THE COST OF COMPROMISE

Response to Revised Application Materials

B-1C Rezoning Request — 473 South Main Street, Harrisonburg, Virginia

“The Link” — TCP Link Harrisonburg, LLC / Timberwolf Capital Partners

Figure 2. Eastbound on Paul St. at Mason St.

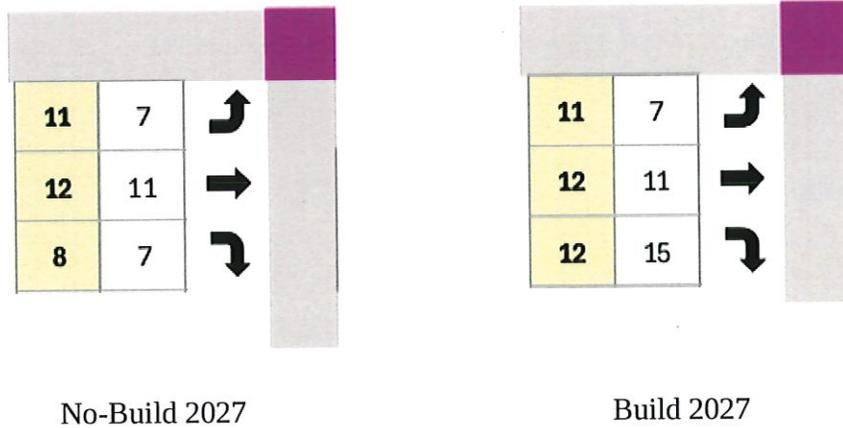
Bernstein’s comparison of the “Build 2027” and “No-Build 2027” models reveals that at **four separate intersections**, the TIA assigns zero additional trips from the project to neighborhood streets:

Intersection / Direction	Build vs. No-Build
Westbound on Paul St. at Mason St.	Identical – zero change
Eastbound on Paul St. at Mason St. (thru + left)	Identical – zero change
Westbound on E. Grattan St. at S. Main St.	Identical – zero change
Northbound on S. Mason St. at MLK Jr. Way	Identical – zero change

This means the traffic engineer modeled a 555-bedroom complex and concluded it would add precisely zero vehicles to these neighborhood streets. This assumption contradicts the applicant’s own proffer of the Paul Street Extension (which presupposes traffic demand on Paul Street) and contradicts the October 2025 Section 7 analysis (which studied the Paul Street route specifically because traffic was expected there).

Figure 3. Westbound on E. Grattan St. at Ss Main St.

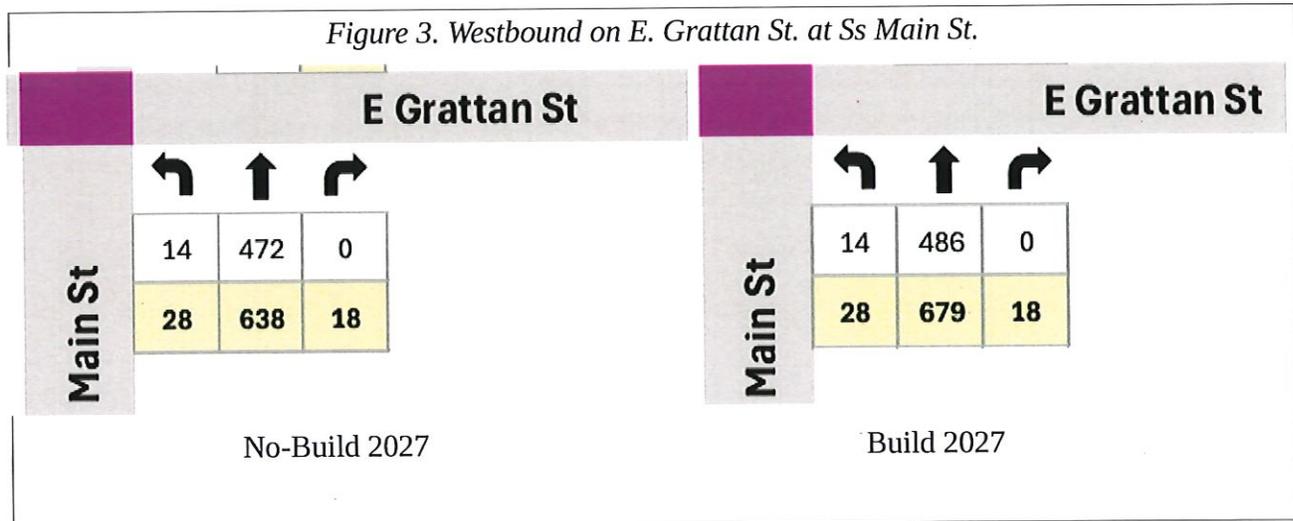
Third, the turning movements in the "Build 2027" model westbound on E. Grattan St. at S. Main St. are identical to those in the "No-Build 2027" model.

It is not clear what the origins and destinations of the current trips are, but it seems very unlikely that the number won't increase as a result of the proposed project

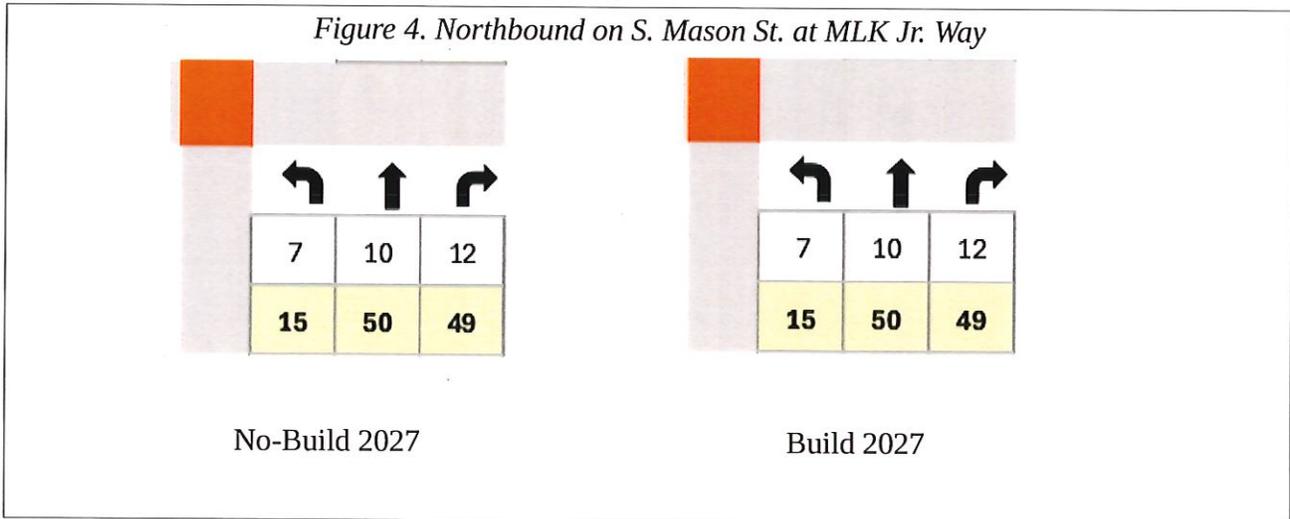
Fourth, the turning movements in the "Build 2027" model northbound on S. Mason St. at MLK Jr. Way are identical to those in the "No-Build 2027" model. This ignores the fact that some percentage of the trips from the East Campus to the proposed project will use S. Mason St. to get to Paul St. and MLK Jr. Way.

Map 1. Some Alternative Paths/Routes from The Link to Target

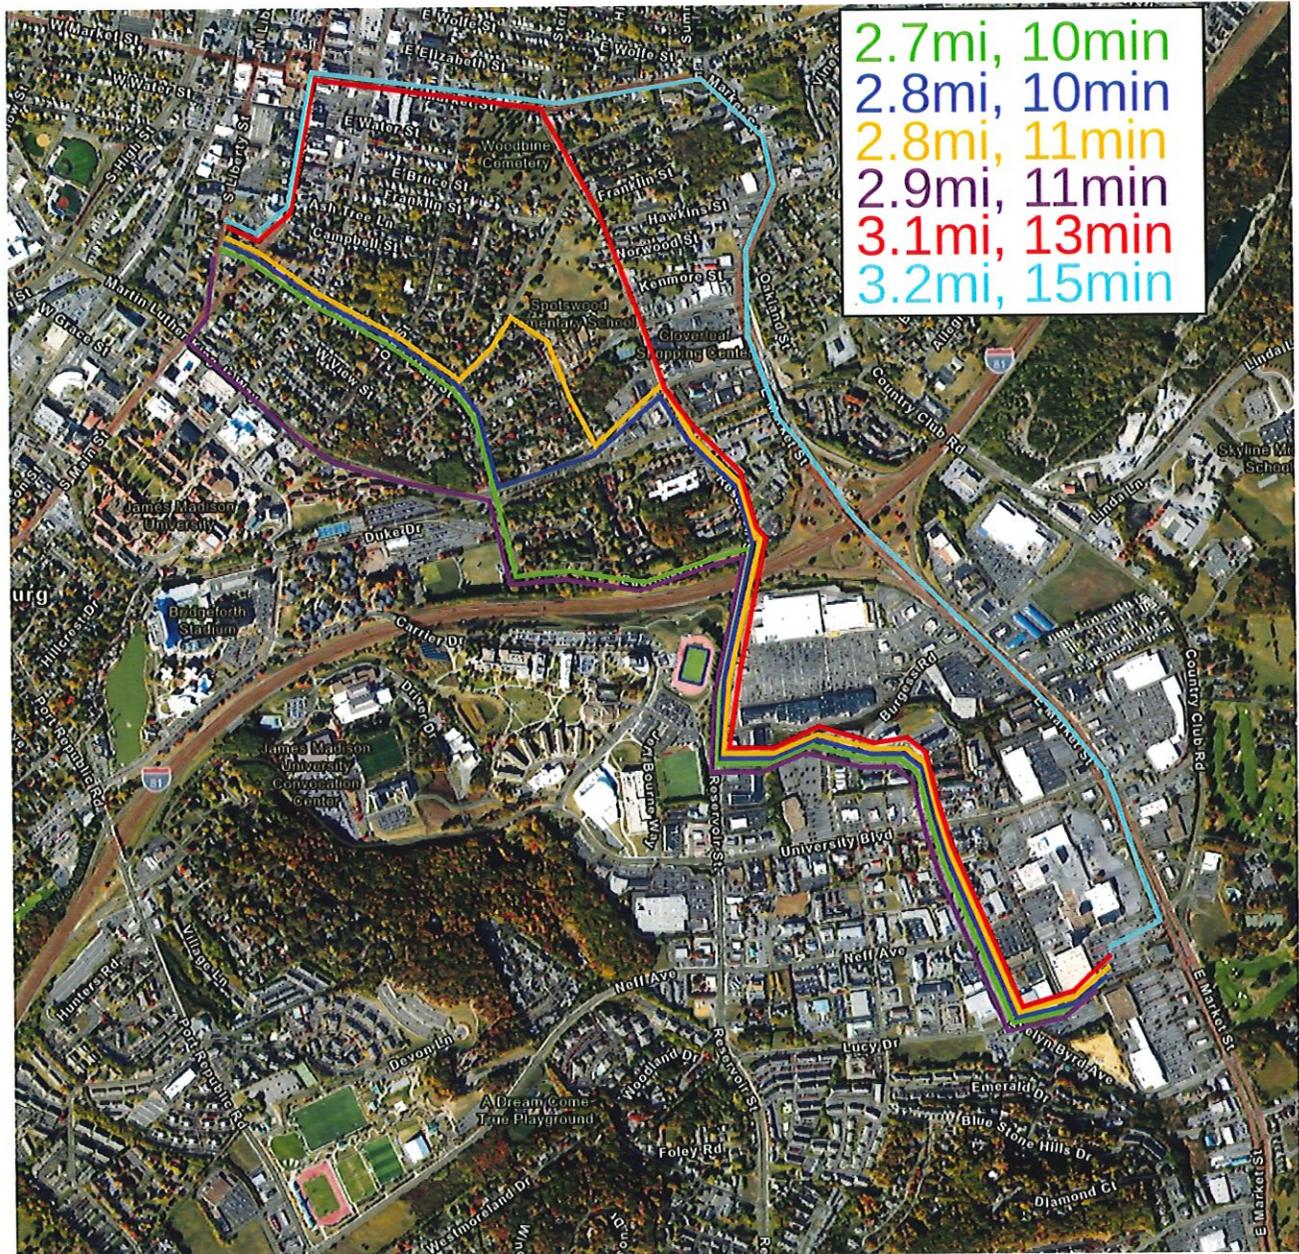
As shown in Map 1, there are many paths/routes from The Link Apartments to Target that have very similar lengths and travel times, and hence are likely to be considered viable alternatives.

Section 7 of *The Link Apartments – Traffic Impact Analysis* dated October 2025 attempts to address this issue, and concludes that the proposed Link Apartments will only have an impact on the route that uses Main St. and Martin Luther King Jr. Way. However, there are several shortcomings of the October 2025 analysis that call its conclusions into question.

Map 3. Overflow On-Street Parking Near The Link

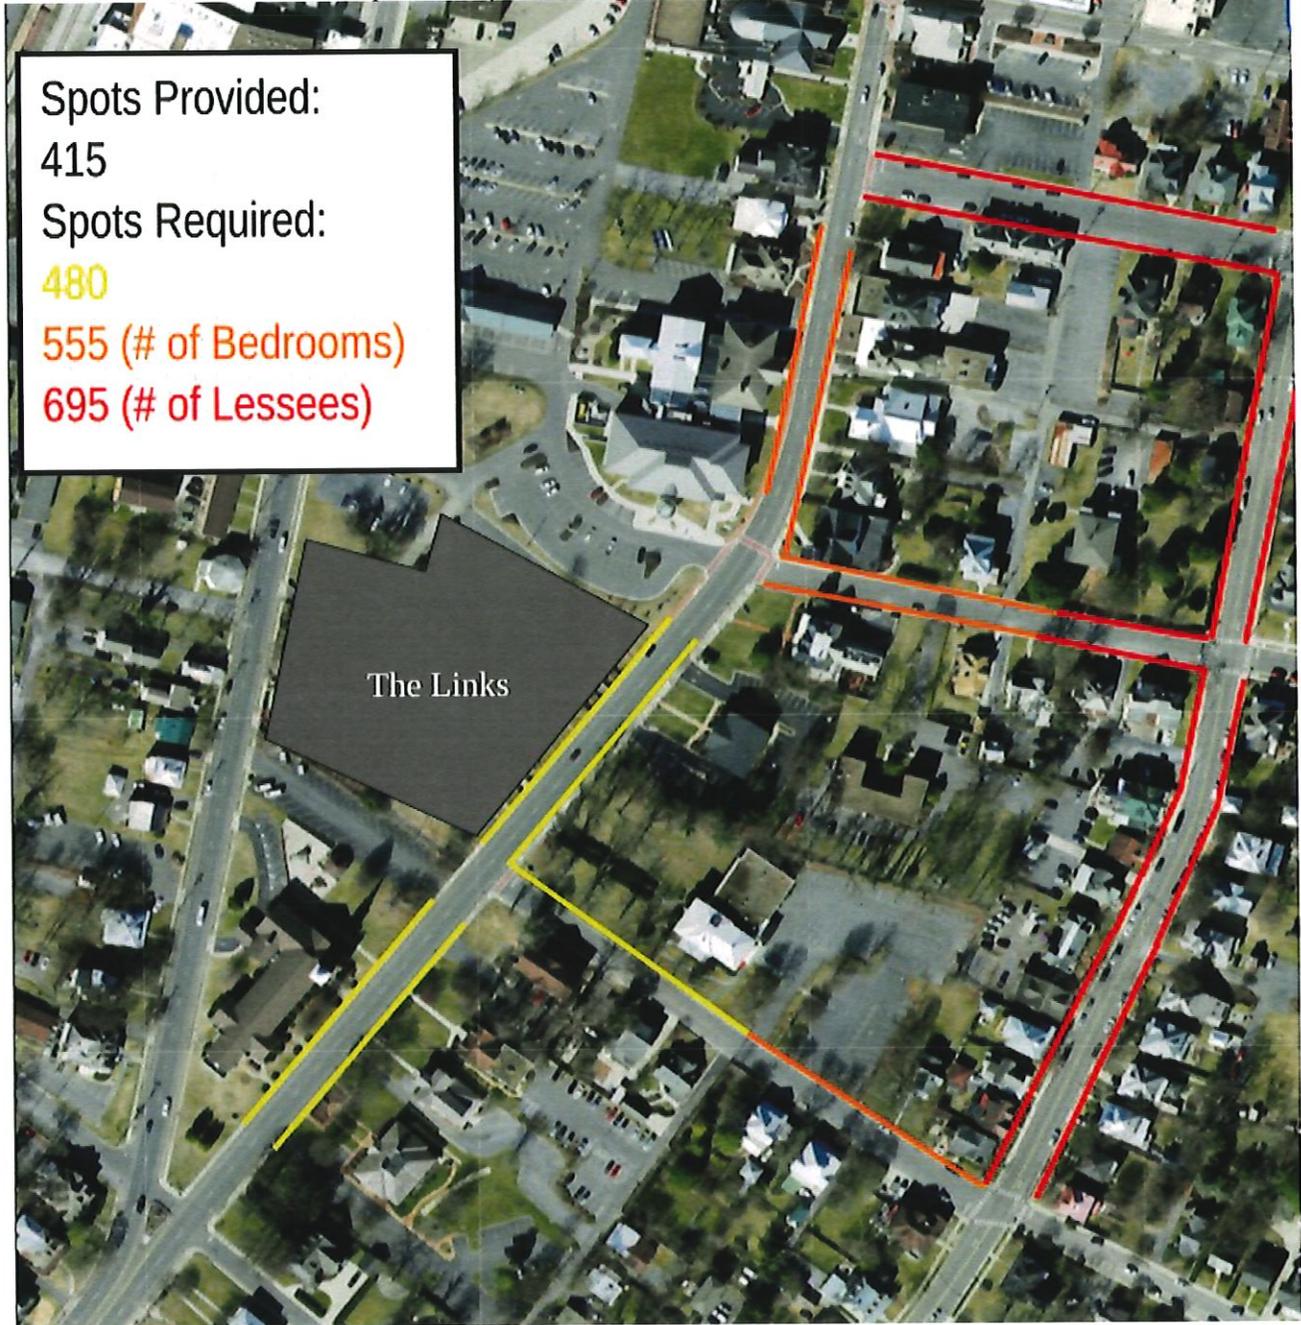
If, in fact, all 480 spaces are required by residents, the closest 65 on-street spaces are on Main St. and Paul St. (as shown in yellow on Map 3). If, instead, there is one car per bedroom (as is possible in a complex in which the residents are college students and/or unmarried professionals), then 555 spaces will be required. The next closest spaces are farther north on Main St., and on Campbell St. (as shown in orange on Map 3). If, in fact, there is one car per lessee, then 695 spaces will be required (with the next closest spaces to the complex shown in red on Map 3).

Of course, many of these spaces are already used by existing residents and shoppers. Hence, either the existing residents and shoppers will be displaced, or the residents of the new complex will have to park farther away. **It is also important to note that the amount of traffic generated by people circling for a space is likely to be significant.**

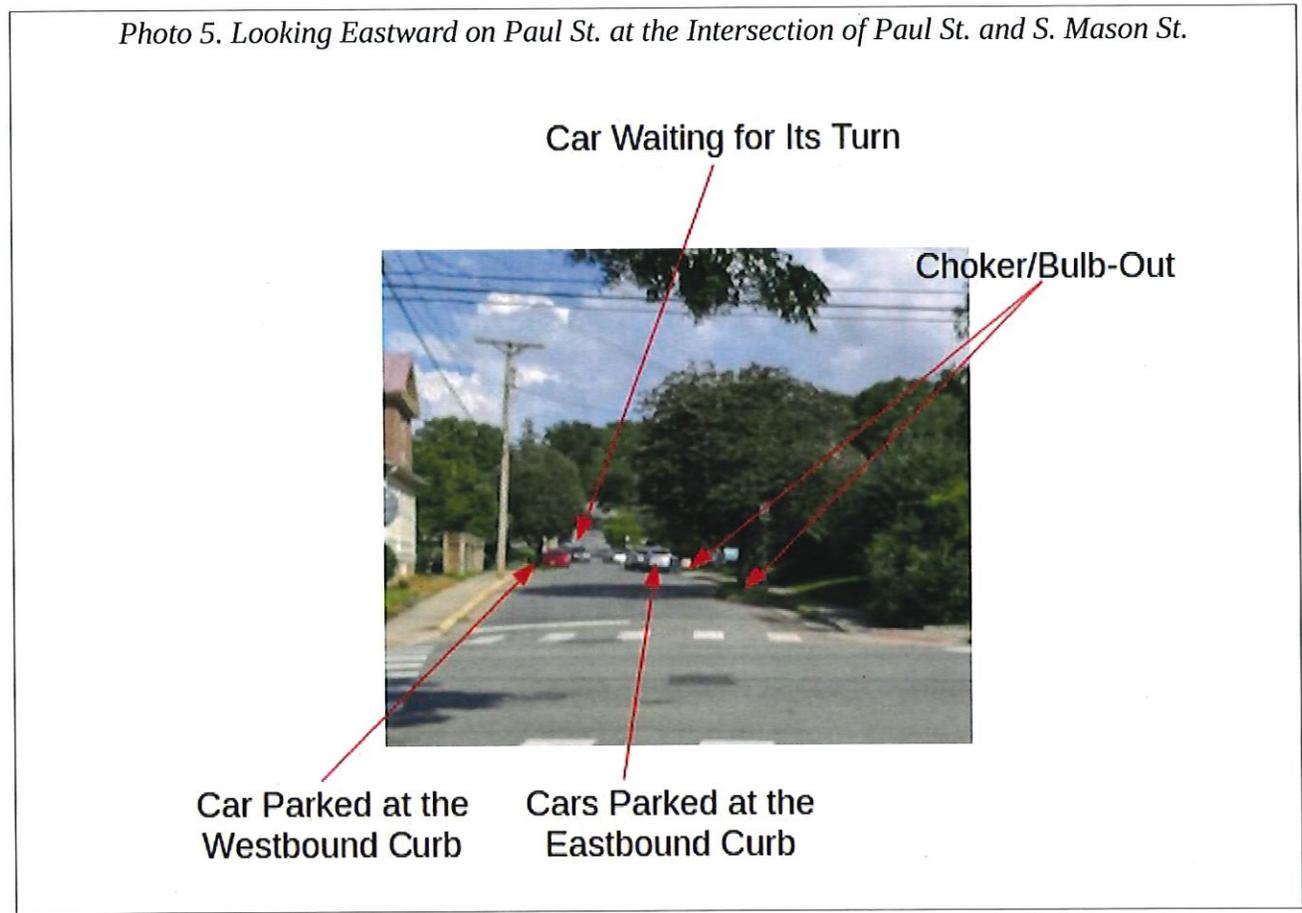
Similarly, at the intersection of Paul St. and S. Mason St., Paul St. goes from a wide segment (to the west of S. Mason St.) to a narrow segment that contains traffic calming measures, and the two segments do not align on the south side of the intersection. This is illustrated in Photo 3 and Photo 4.

S. Mason St. is very difficult to cross as a result of the geometry. This difficulty is exacerbated by the fact that there are chokers on the narrow segment and by the fact that cars are always parked on both sides of the street. The result is that the effective width of this segment of Paul St. is only 15 feet. Hence, cars must take turns using this segment. This is illustrated in Photo 5.
